Access Compliance Report Public Rights-of-Way (Curb Ramps)

Main Street: FOSTER_RD Cross Street: INVERNESS_DR Location: E

ADA ID: RPRK211216130451 Ramp Type: Type 1 - Perpendicular Diagonal Initial Pass/Fail: Pass Overall Compliance: No Severity Score: 10

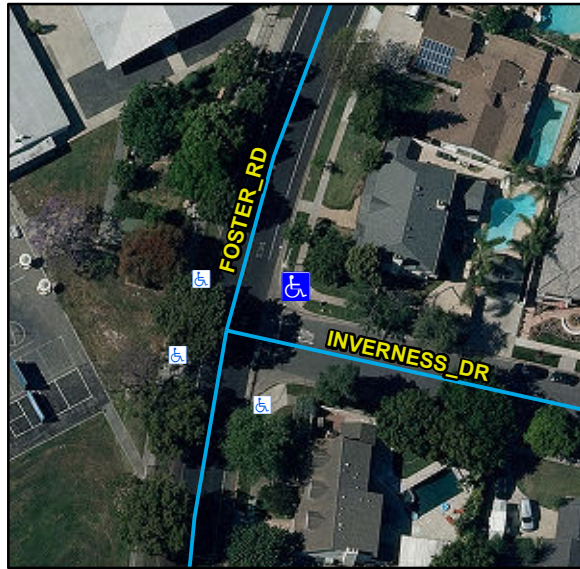
Compliance	Description	Data	Compliance	Description	Data
N/A	Ramp Length (in)	85	N/A	Flare Type LT	
Yes	Ramp Width (in)	48			Sloped
Yes	Ramp Run Slope (%)	7.8	N/A	Flare Slope LT (%)	5
Yes	Ramp Cross Slope (%)	0.1	N/A	Flare Traversable LT	No
N/A	Landing Present	Yes	N/A	Flare Type RT	
N/A	Landing Length (in)	49			Sloped
Yes	Landing Width (in)	48	N/A	Flare Slope RT (%)	4.3
No	Landing Run Slope (%)	2.5	N/A	Flare Traversable RT	No
Yes	Landing Cross Slope (%)	0.3	No	DWS Provided	No
N/A	Landing Movement Obstructed?	No	N/A	DWS Contrast	N/A
	Landing Movement Type	N/A	N/A	DWS Length (in)	N/A
N/A	Landing Shared	No	N/A	DWS Full Width	N/A
N/A	Clear Space	Yes	N/A	DWS Offset Left (in)	N/A
N/A	Clear Space To Crosswalk (in)	48	N/A	DWS Offset Right (in)	N/A
N/A	Marked Crosswalk 1	No	N/A	Marked Crosswalk 2	No
	Crossing 1 Direction	NW		Crossing 2 Direction	SW
	Marked Crosswalk 1 Width (in)	N/A		Marked Crosswalk 2 Width (in)	N/A

N/A	Ramp Inside Crosswalk 1	N/A	Yes	Ramp Inside Crosswalk 2	N/A
	Crossing 1 Slope (%)	6.1		Crossing 2 Slope (%)	3.3
	Crossing 1 Cross Slope (%)	0.6		Crossing 2 Cross Slope (%)	1
Yes	Gutter Ponding	No	Yes	Curb Slope	0.7
Yes	Gutter Lip Height (in)	0		Road Run Slope (%)	0.7
Yes	Gutter Run Slope (%)	0.2		Road Cross Slope (%)	0.9
Yes	Gutter Cross Slope (%)	0.4			
Yes	Overall Surface Condition: Acceptable		Yes	Perp Joint Present	Yes
	Cross Gutter Present?	Yes		Spandrel Present?	Yes
	Replace Cross Gutter?	No		Replace Spandrel?	No

Remove & Replace Curb Ramp With Two New Directional Ramps or Equivalent.
